APPLICATION NO.	FILING DATE	FIRST NAMED INVENTOR	ATTORNEY DOCKET NO.	CONFIRMATION NO.
10/671,842	09/25/2003	Michael D. Brookshire	121236.00003	9648
26707 7590 04/29/2010 QUARLES & BRADY LLP RENAISSANCE ONE TWO NORTH CENTRAL AVENUE PHOENIX, AZ 85004-2391				
EXAMINER REESE, DAVID C				
ART UNIT 3677		PAPER NUMBER		
NOTIFICATION DATE 04/29/2010		DELIVERY MODE ELECTRONIC

Office Action Summary

DETAILED ACTION

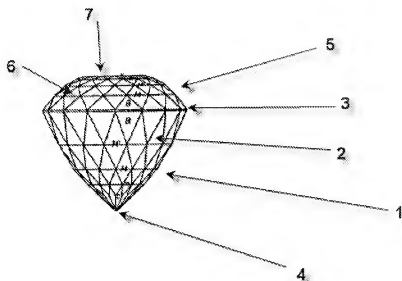
As for Claim 40, Diagrams for Faceting reference discloses of a cut gemstone (see figure 9), comprising:

a pavilion (1) having a plurality of facets (2) disposed from a girdle (3) to a culet (4); and
a dome-shaped crown (5) disposed above the girdle (3), wherein the girdle (3) extends no further than a widest circumference (bottom of 5) of the dome-shaped crown (5) and the pavilion (1) extends no further than a widest circumference of the girdle (3), the dome-shaped crown (5) formed from a plurality of sets of facets (6) cut with monotonically decreasing angles to form a curved contour in accordance with a dome shape from the girdle (3) to an apex (7) of the dome-shaped crown (5), each facet (6) within the sets of facets (6) being polygonal in shape with opposing corners of the polygon nested between adjacent facets (6).

Re: Claim 44, wherein the dome-shaped crown (5) is formed from at least five sets of facets (6) (see also figure ID on page 9 of "Diagrams") with monotonically decreasing angles to form the curved contour in accordance with the dome shape (5).

As for Claim 47, Diagrams for Faceting reference discloses of a cut gemstone (see figure below), comprising:

a pavilion (1) having a plurality of facets (2) disposed from a girdle (3) to a culet (4); and
a dome-shaped crown (5) disposed above the girdle (3), wherein the girdle (3) extends no further than a widest circumference (bottom of 5) of the dome-shaped crown (5) and the pavilion (1) extends no further than a widest circumference of the girdle (3), the dome-shaped crown (5) formed from a plurality of sets of facets (6) cut with monotonically decreasing angles to form a

curved contour in accordance with a dome shape from the girdle (3) to an apex (7) of the dome-shaped crown (5).

Re: Claim 48, wherein each facet (6) within the sets of facets (6) is polygonal in shape with opposing corners of the polygon nested between adjacent facets (6).

Re: Claim 54, wherein the dome-shaped crown (5) if formed from at least five sets of facets (6) (see also figure ID on page 9 of "Diagrams") with monotonically decreasing angles to form the curved contour in accordance with the dome shape (5).

As for Claim 13, “Diagrams” teaches of a diamond (see figure above), comprising:

a pavilion (1) extending from a girdle (3) to a culet (4), wherein the girdle (3) extends no further than a widest circumference of the crown (5) and the pavilion (1) extends no further than a widest circumference of the girdle (3); and

a crown (5) in the form of a symmetrical hemisphere formed from at least five sets of facets (6) between the girdle (3) and an apex (7) of the crown (5) having a first set of facets (6) disposed above the girdle (3) and a second set of facets (6) disposed between the first set (6) of facets and an apex (7) of the crown (5), wherein the first set of facets (6) is cut at a first angle with respect to a reference line which is tangential to the apex (7) of the crown (5) and the second set of facets (6) is cut at a second angle with respect to the reference line which is less than the first angle, each facet (6) within the first and second sets of facets (6) being hexagonal in shape with opposing corners of the hexagon nested between adjacent facets (in view of remarks above).
